RESPONSE TO AN BORD PLEANÁLA OPINION

**PROPOSED MIXED USE RESIDENTIAL DEVELOPMENT AT A COMBINED
SITE LOCATED AT THE JUNCTION OF BELGARD SQUARE NORTH AND
BELGARD ROAD, TALLAGHT, DUBLIN 24**

TOM PHILLIPS + ASSOCIATES
Town Planning Consultants
80 Harcourt Street
Dublin 2
D02 F449

December 2018

Fig. 2: Integration of the development with surrounding area

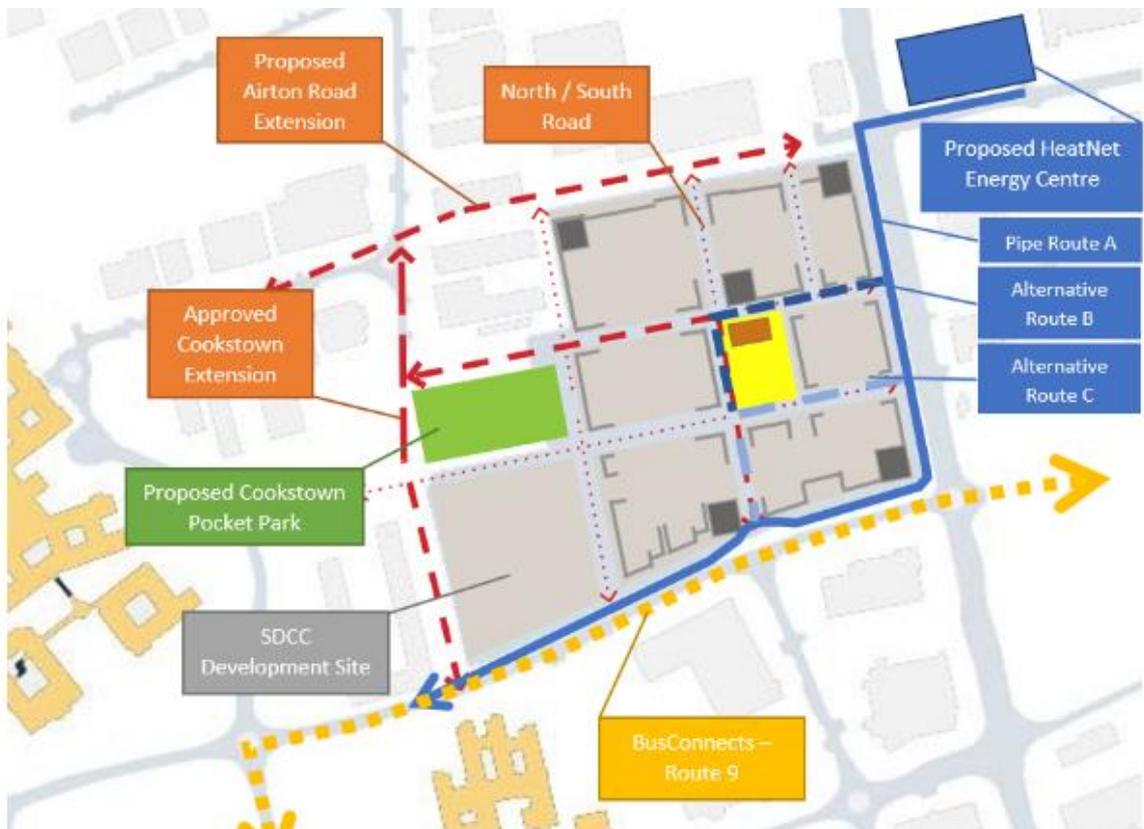
The documentation should indicate how the timeframe in which the proposed development would proceed and that the infrastructure required to support and facilitate development on the rest of the application site and on neighbouring land was provided in a timely manner. The documentation should also demonstrate that the layout and design of the development would be compatible with the proper and sustainable development of adjoining land”.

The design team has ensured that the development will be compatible with the proper planning and sustainable development of adjoining land, and the wider area, through establishing a ‘Masterplan’ approach to the development of the site.

This masterplan approach takes full cognisance of the Phase I and Phase II proposals, in addition to the development potential of the adjoining land to the west in the ownership of SDCC. The proposed development has been designed as a result of this masterplan approach and in line with ongoing discussions with SDCC which ensures that there will be no conflict with the future development of their lands.

Cognisance has been had to external local proposals, which may integrate with the proposed scheme including the Cookstown Extension Road as recently approved under the Part 8 process and *BusConnects* programme. OCSC met with the Council’s Cookstown Extension Road design team and agreed interfaces between the Part 8 road through the SDCC site and connecting to the proposed scheme. In addition, OCSC have liaised with the NTA with regard to accommodating the *BusConnects* programme on Belgard Square North. Therefore, the proposed development is fully compatible with these proposals.
